25 WEBSTER ST. PHASE 2

SB# 06-22

STAFF REPORT

PURPOSE OF PLAN: To subdivide Map 181 Lot 001-001 into four (4) residential building lots served by a common driveway and to relocate the lot line of Map 181 Lot 001-000.

SHEET: 7 of 14

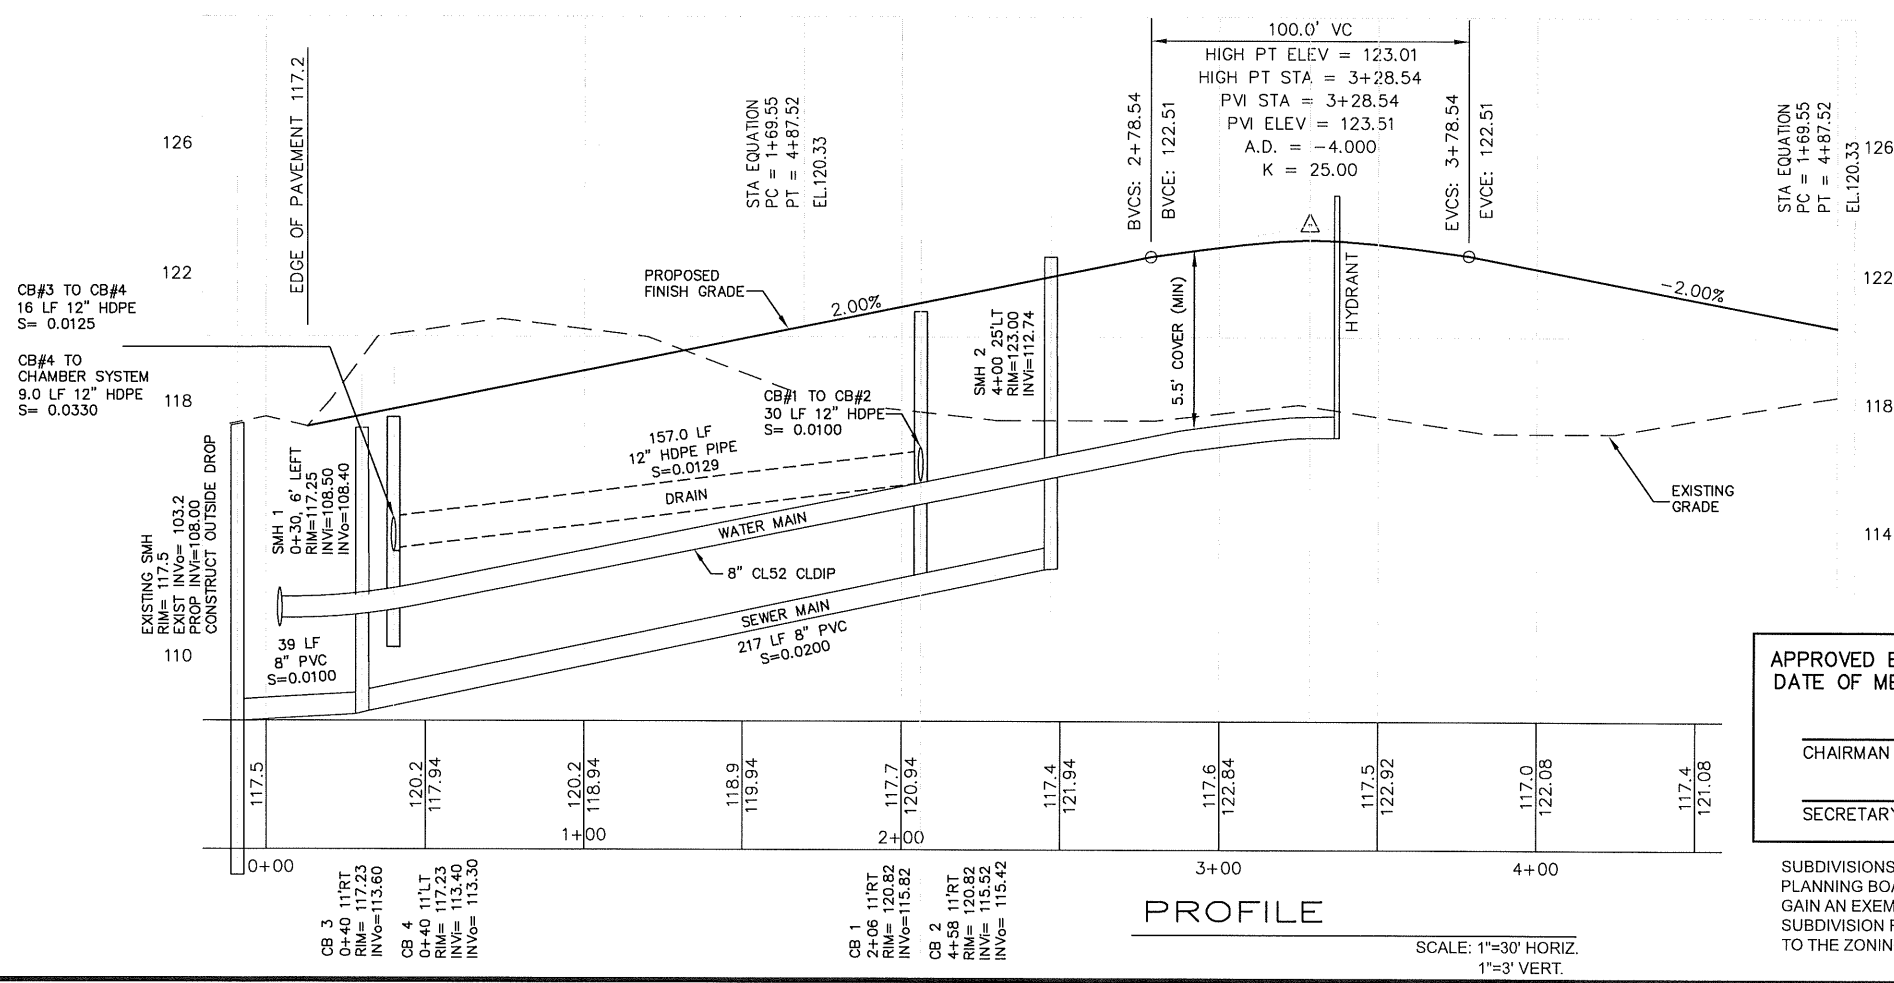
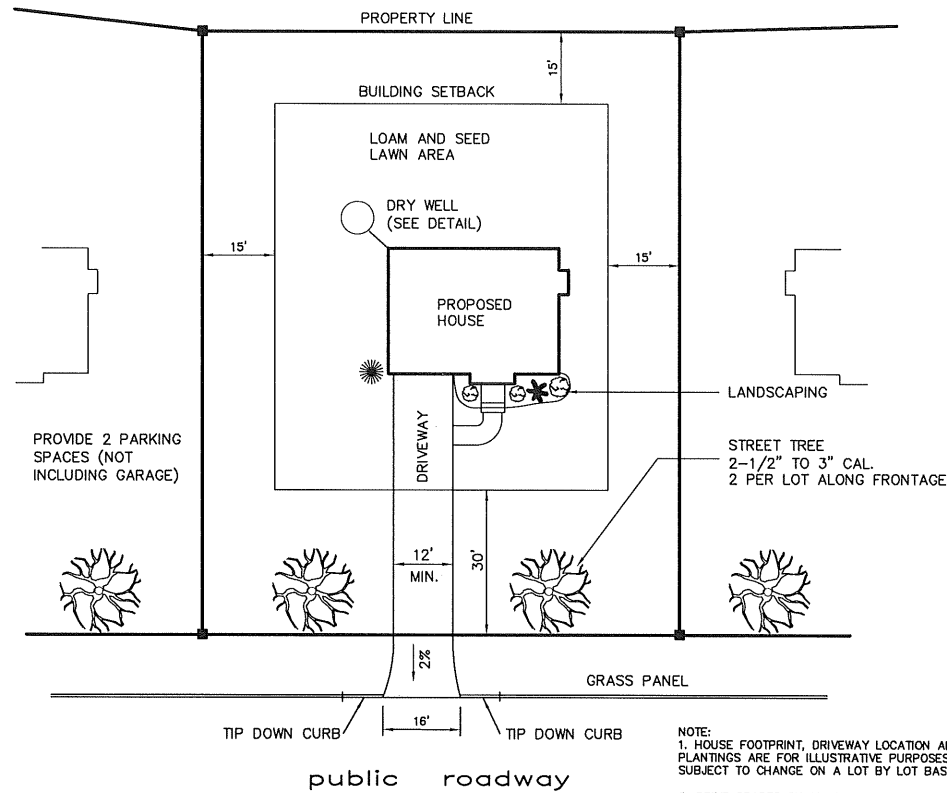
- f. HR 276-11.1.B.(17). & 289-27.B.(7). The applicant has not provided any benchmark information.
- g. HR 276-11.1.B.(20). The applicant has not noted existing building heights on the plan set, including the existing home to be relocated.

- j. HR 290-6.A.8. We note the requirement of the applicant to coordinate a pre-construction meeting with the Town Engineer.
 - k. HR 290-7.A.6. The applicant should provide information as to how the stormwater system is designed to account for frozen ground conditions.

- o. ETGTD 920.4.1 through 920.4.4. The applicant shall illustrate the locations of the requested items upon the plan set.
 - p. ETGTD 930.1. The applicant should review the depth of the drainage within the roadway, it does not meet Town minimum depth of 4' of cover.

- c. HR 289-27.B.(5). The applicant should show proposed water and sewer service connections for each lot, including curb stop and sewer cleanout locations.

- f. HR 276-11.1.B.(17). & 289-27.B.(7). The applicant has not provided any benchmark information. **A bench has been added to sheet 7.**
 - g. HR 276-11.1.B.(20). The applicant has not noted existing building heights on the plan set, including the existing home to be relocated.

- j. HR 290-6.A.8. We note the requirement of the applicant to coordinate a pre-construction meeting with the Town Engineer. **Note 8 has been added to sheet 7.**

- o. ETGTD 920.4.1 through 920.4.4. The applicant shall illustrate the locations of the requested items upon the plan set. **These items have been added to sheet 7 accordingly.**

- c. HR 289-27.B.(5). The applicant should show proposed water and sewer service connections for each lot, including curb stop and sewer cleanout locations. **Connections have been added to the plan sheet 7.**

- l. HR 276-13.E. The applicant has not shown the proposed means for utility connections (electric/telephone/cable) to the individual lots within the subdivision. The Regulation requires these to be underground. **The underground utility main has been added to sheet 7.**

- c. The Town should reserve the right to require additional erosion control measures. **This is noted on the plan sheet 7.**
8. State and Local Permits

- c. Additional local permitting may be required. **So noted.**
9. Other
- a. ETGTD Section 565.1.1. The applicant is reminded that the Town of Hudson has specific requirements for the importing of off-site fill materials for use in constructing this project. We recommended that these requirements be stated on the plans for the Contractors attention. **These notes have been added to sheet 7.**

TYPICAL ROADWAY SECTION

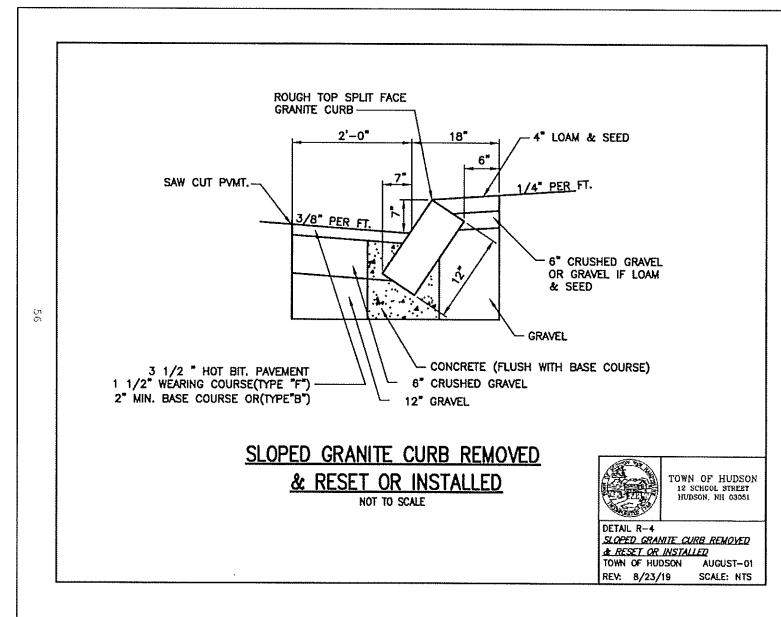
- j. Hudson Engineering Technical Guidelines & Typical Details (ETGTD) Detail R-1. The Typical Roadway Section on sheet 6 of 12 includes 3 inches of bituminous pavement. The Town standard requires 3.5 inches. The applicant should also correct the 22' measurement call out at the bottom of the detail.

- j. Hudson Engineering Technical Guidelines & Typical Details (ETGTD) Detail R-1. The Typical Roadway Section on sheet 6 of 12 includes 3 inches of bituminous pavement. The Town standard requires 3.5 inches. The applicant should also correct the 22' measurement call out at the bottom of the detail. **This detail has been revised accordingly.**

Post-Development Drainage Area Plan

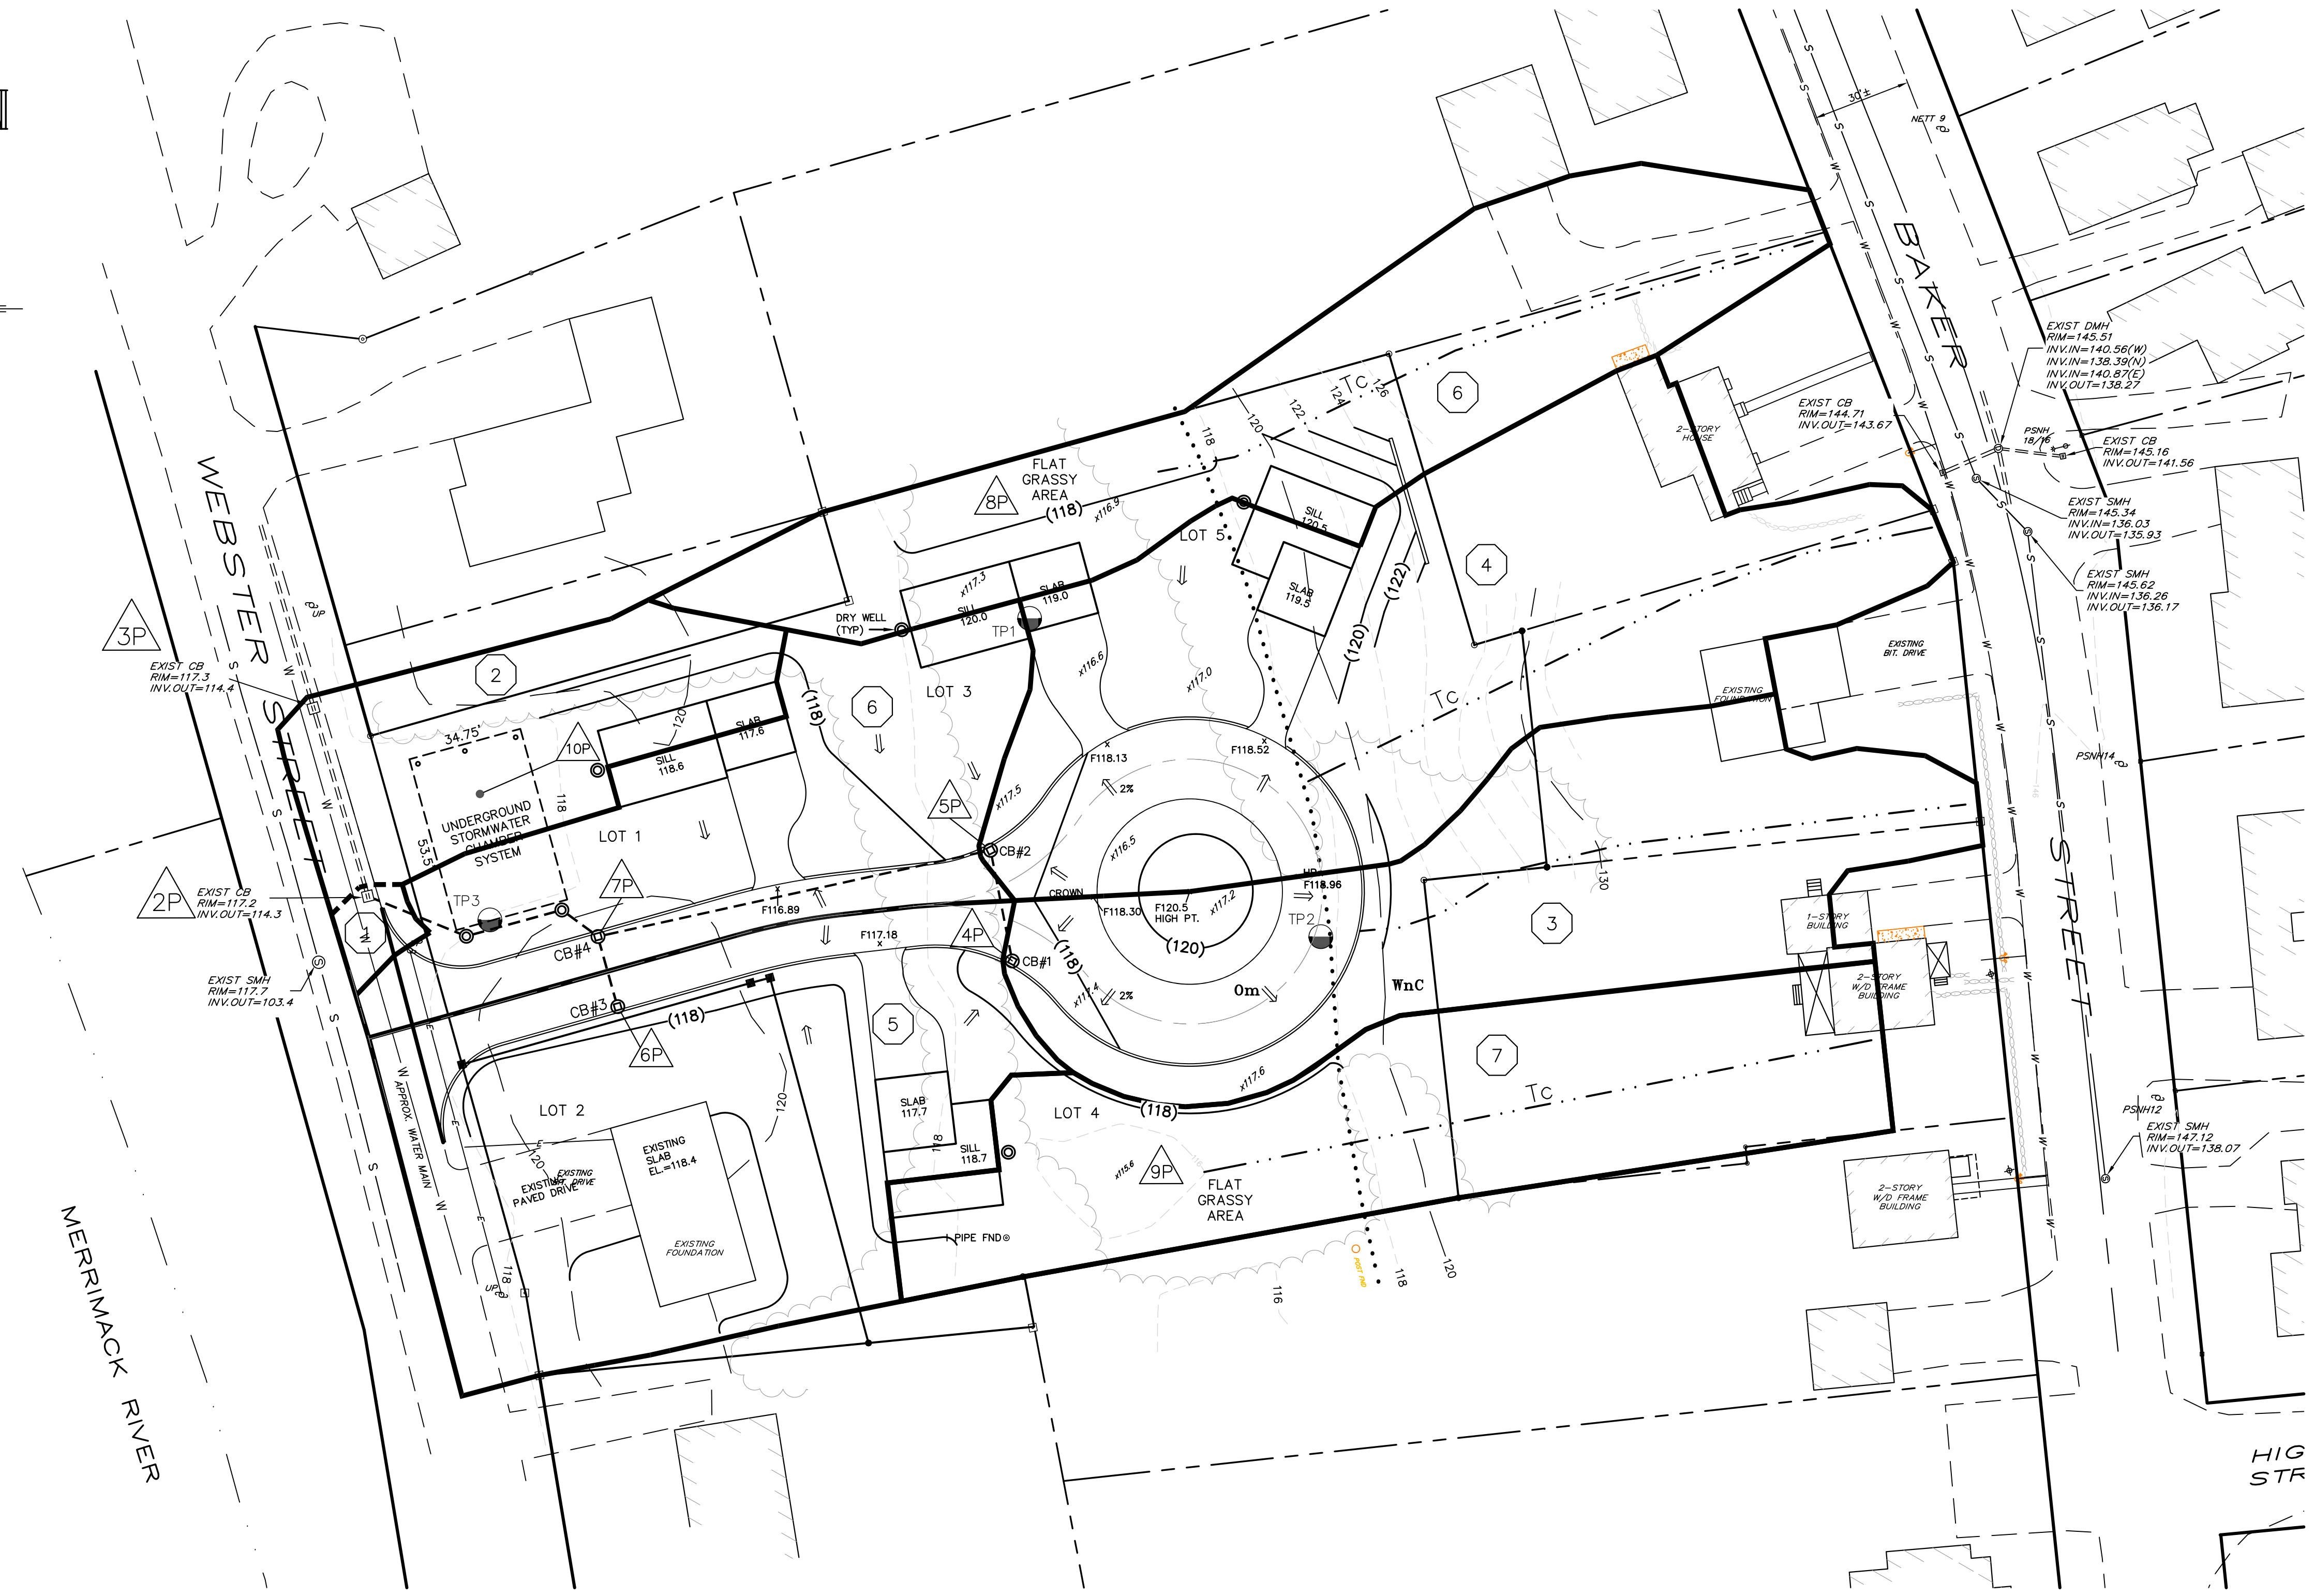
- h. HR 290-5.A.11. We note that nodes 5R and 10P are not illustrated on the pre-development drainage area plan, and it appears that node 6P is listed twice. The applicant should clarify and list all nodes on the drainage area plan.
